ACCESSION NBR: 8310240150 DOC. DATE: 83/10/14 NOTARIZED: NO DOCKET #
 FACIL: 50-397 WPPSS Nuclear Project, Unit 2, Washington Public Power 05000397
 AUTH. NAME: SORENSEN, G.C. AUTHOR AFFILIATION: Washington Public Power Supply System
 RECIP. NAME: SCHWENCER, A. RECIPIENT AFFILIATION: Licensing Branch 2

SUBJECT: Provides status info on Branch Technical Position PSB-1 commitments per S Rhaw 830905 request. GE field dispositions re final Div 3 second level undervoltage protection design & two oversize drawings encl. Aperture cards available in PDR.

Subject: NUCLEAR PROJECT NO. 2
BRANCH TECHNICAL POSITION PSB-1
COMMITMENT IMPLEMENTATION STATUS

FIELD DEVIATION
DISPOSITION REPORT

TITLE METAL CLAD SWITCHGEAR
UNIT-102
Zone B-E, 1-5

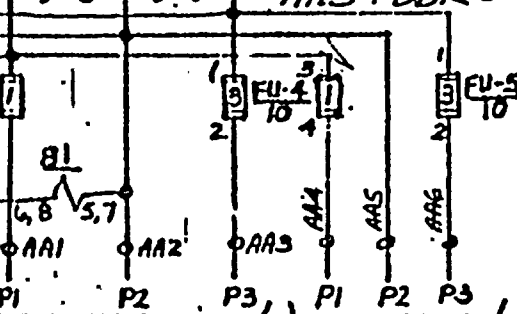
NOTE: RELAYS 62S3 & 62S4
ARE LOCATED ON LEFT PANEL
IN UNIT 102. THIS DRAWING
WAS REDRAWN FOR CLARITY
TO SHOW REVISED CONFIGURATION.

REMOVE RELAYS PER THIS FDDR

INSTRUMENT NO. 0184B1719SH 5 REV 1TITLE Electrical Diagram Unit-102 Potential and
Undervoltage CircuitTHIS SHEET REVISES SHEET 6 OF KKI-1214, REV. 0
5

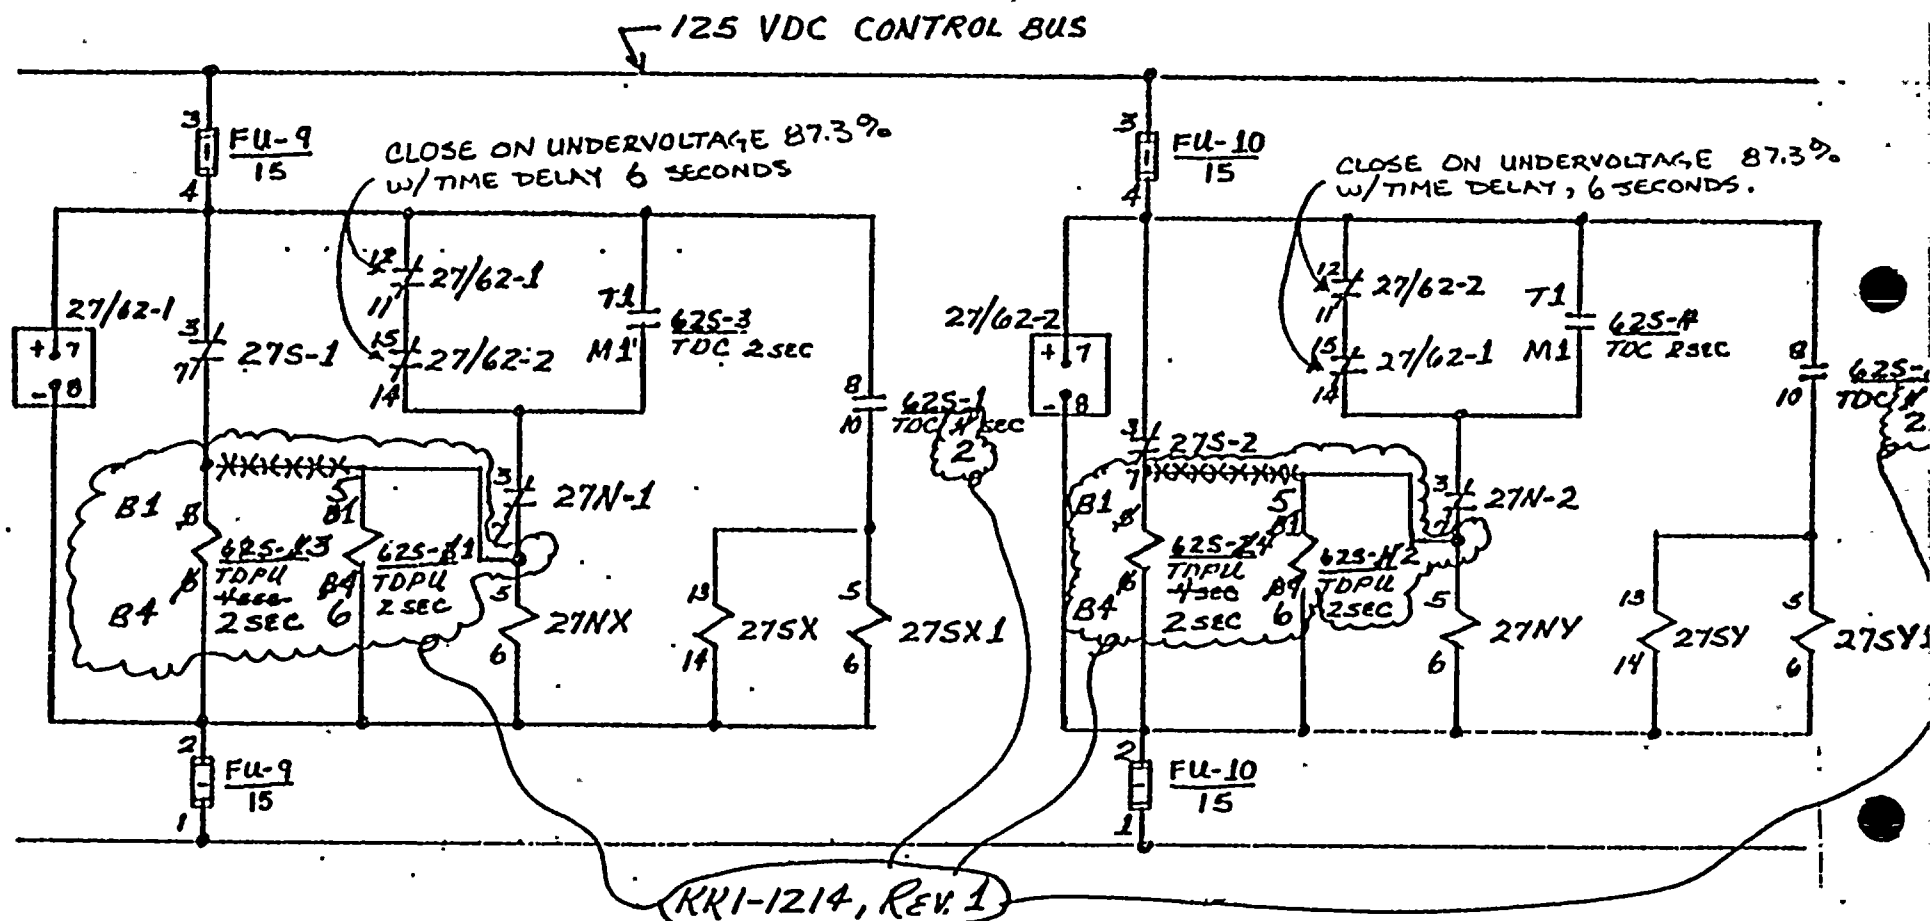
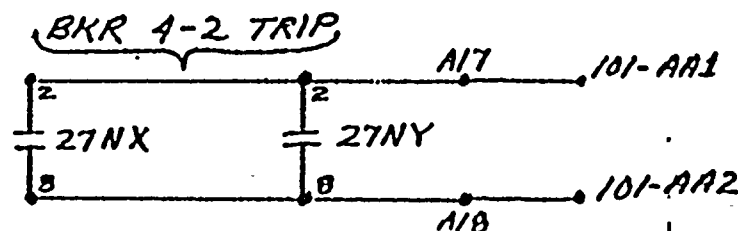
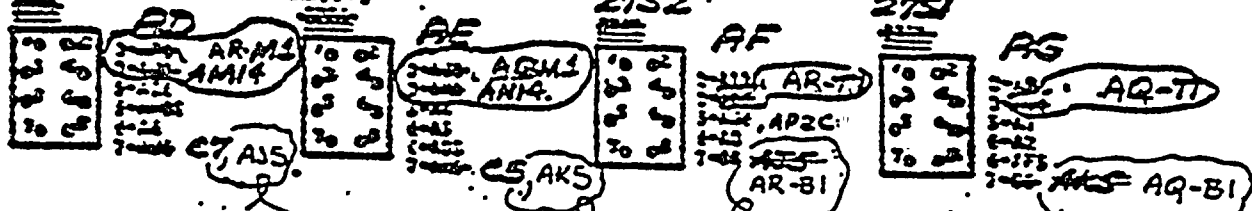
1. 27/62-1/2 RELAY COILS, ARE
SHOWN AS THE SAME IN BOTH
CIRCUITS

REVISION TO DWG. 0184B1719, Sh. 5

DOCUMENT NO. 018481719
 TITLE Electrical Diagram Unit-102 Potential and
 Undervoltage Circuit
 Zone

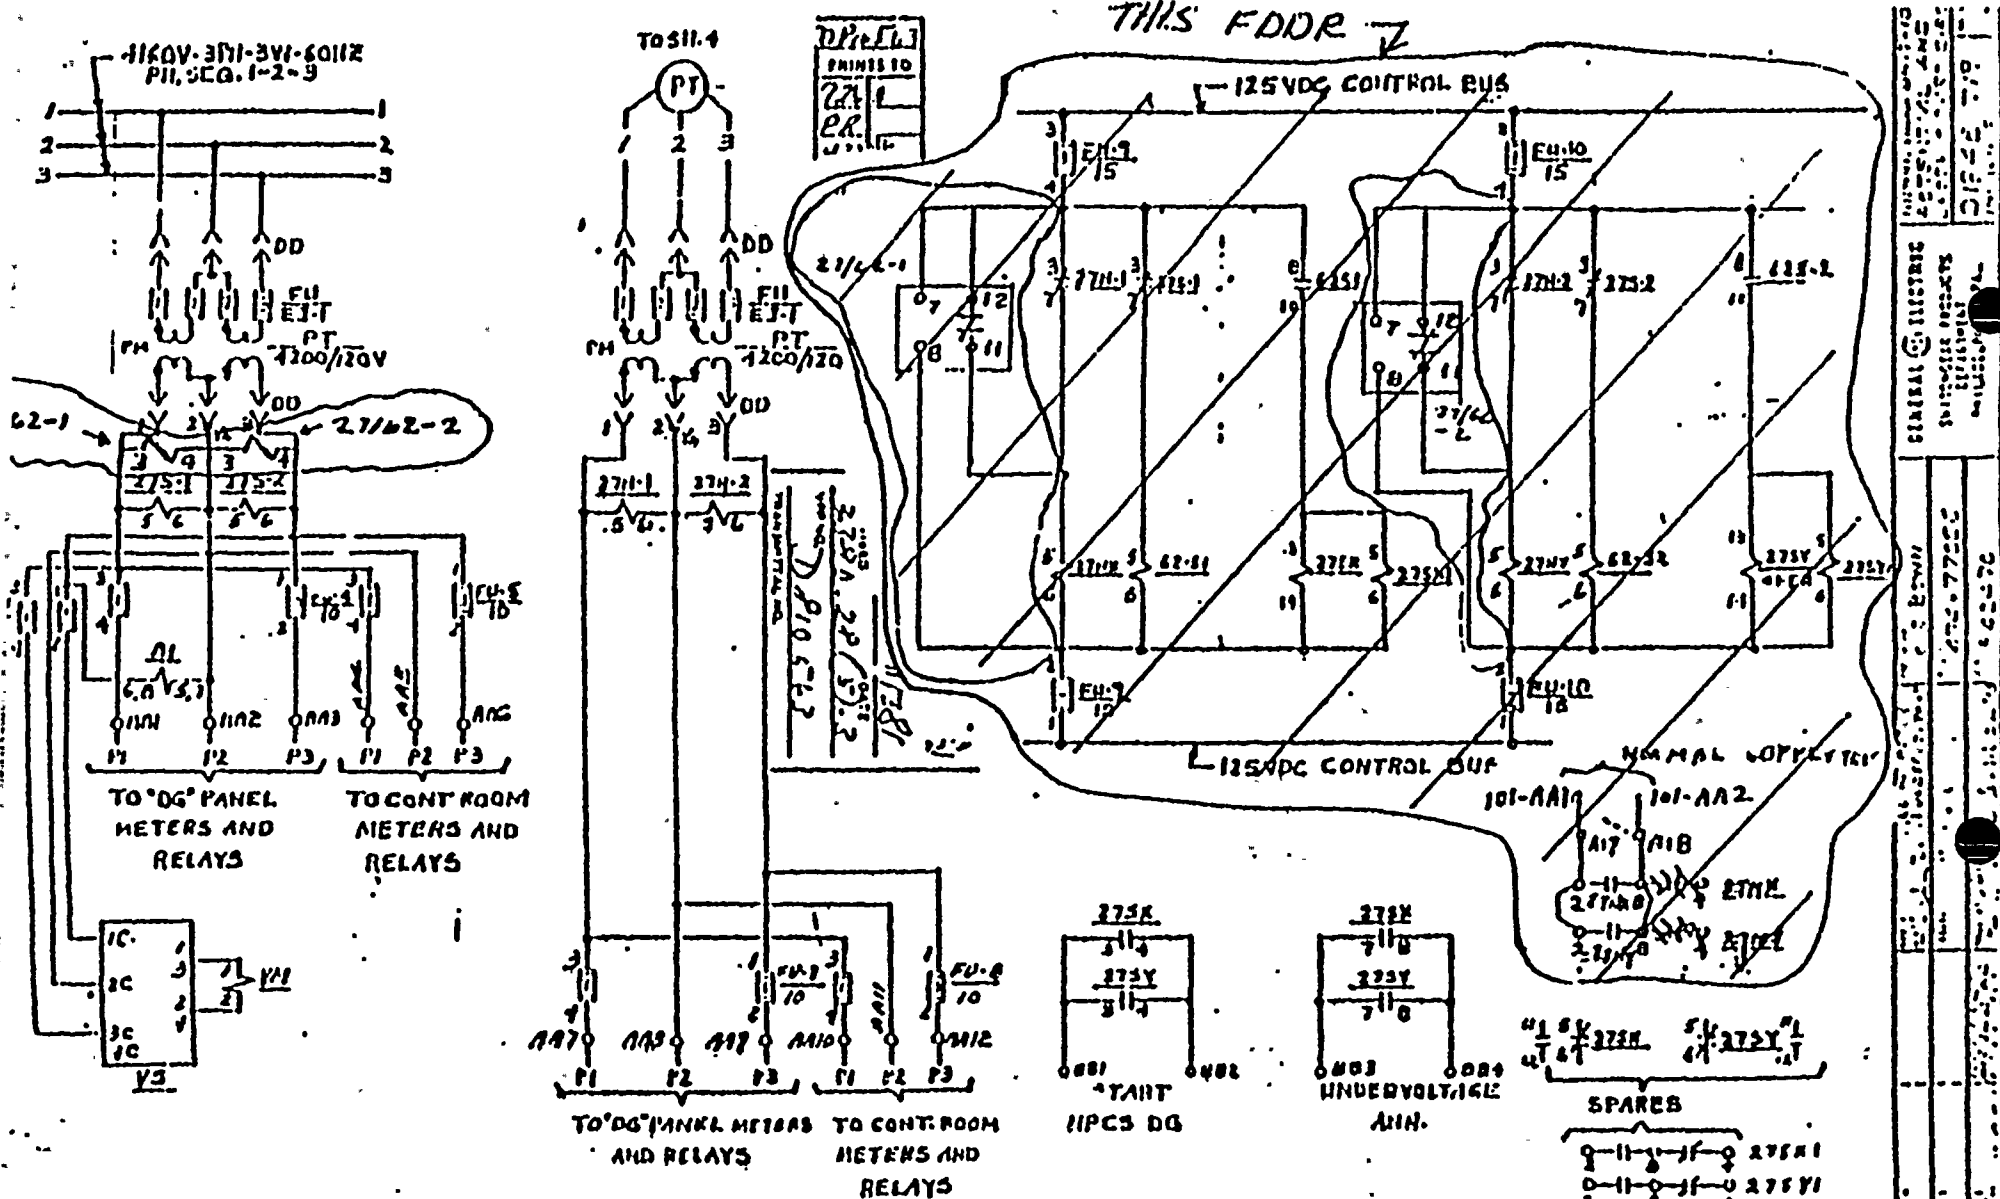
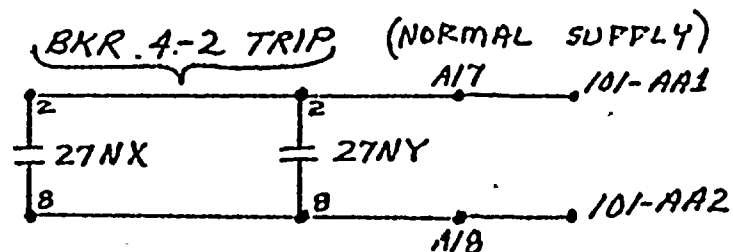
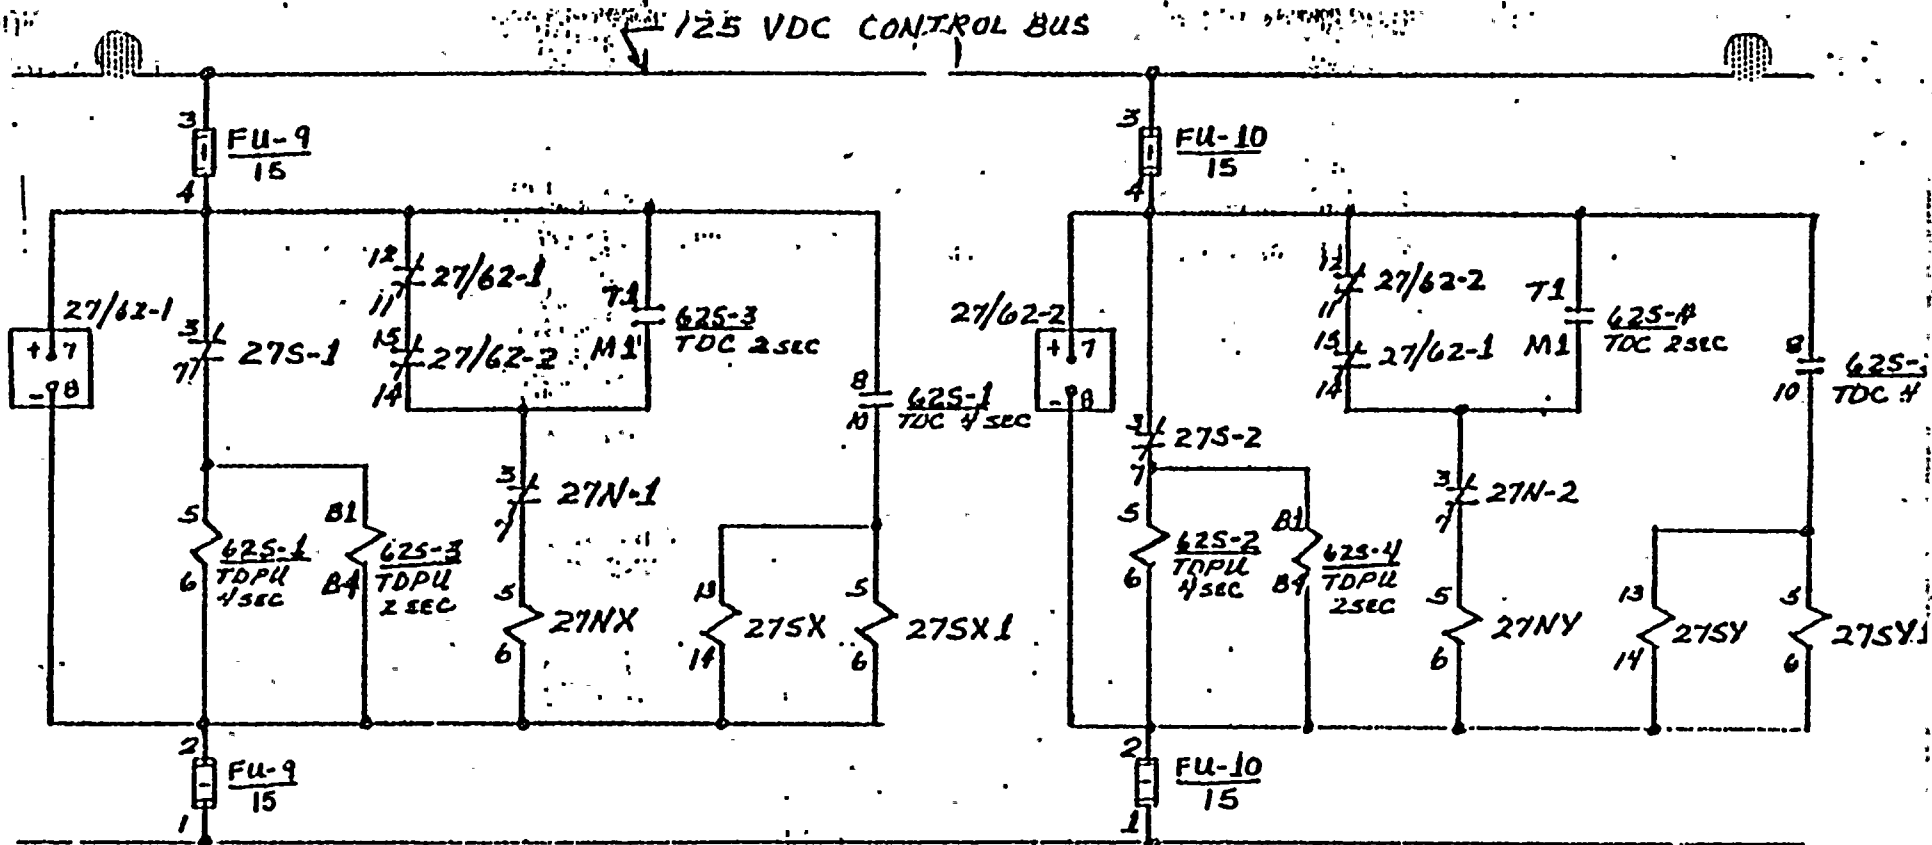
REVISION TO DWG. 0184B1719, Sh. 5

731E302 AD HPCS POWER SUPPLY ONE LINE DIAGRAM

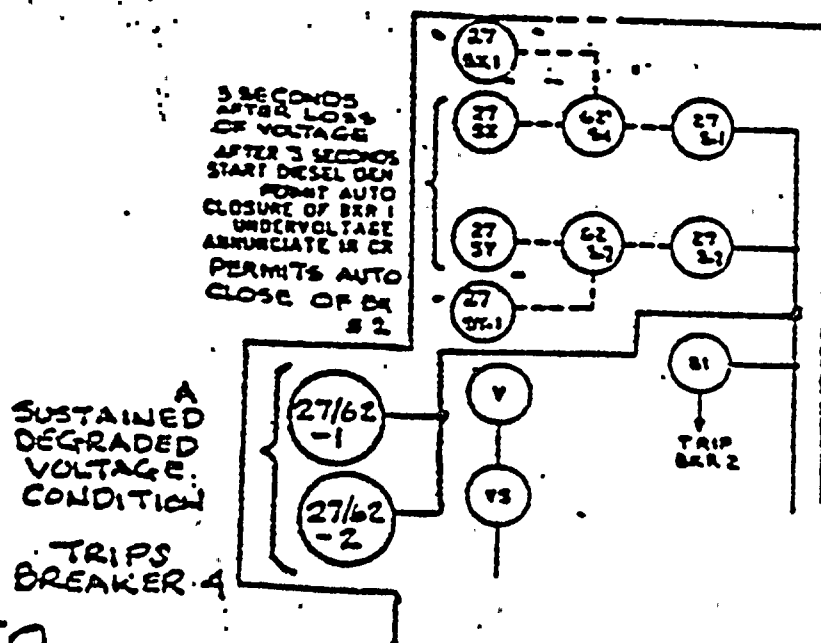
SH.1 (ZONE D-6), CHANGE AS SHOWN;
FROMTO

Document No. T31E302AD Sh | Rev 1

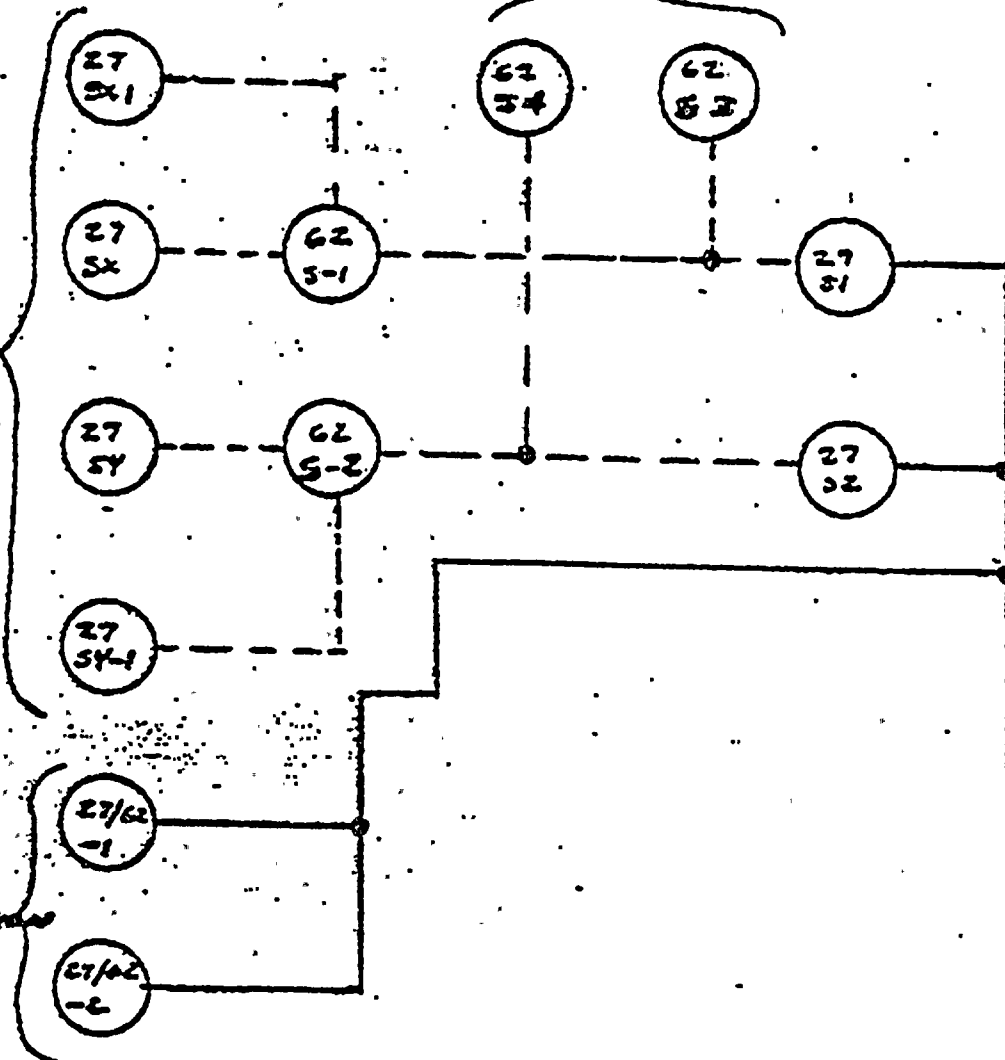
2 SECONDS AFTER
LOSS OF VOLTAGE
TRIP BREAKER 4

4 SECONDS
AFTER LOSS
OF VOLTAGE
START D/G
PERMIT AUTO
CLOSURE OF BRK 1
UNDER-
VOLTAGE
ARMOR, 10 CL.
PERMIT AUTO
CLOSURE OF
BRK 2

A
SUSTAINED
DEGRADED
VOLTAGE CONDITION
TRIPS
BREAKER 4
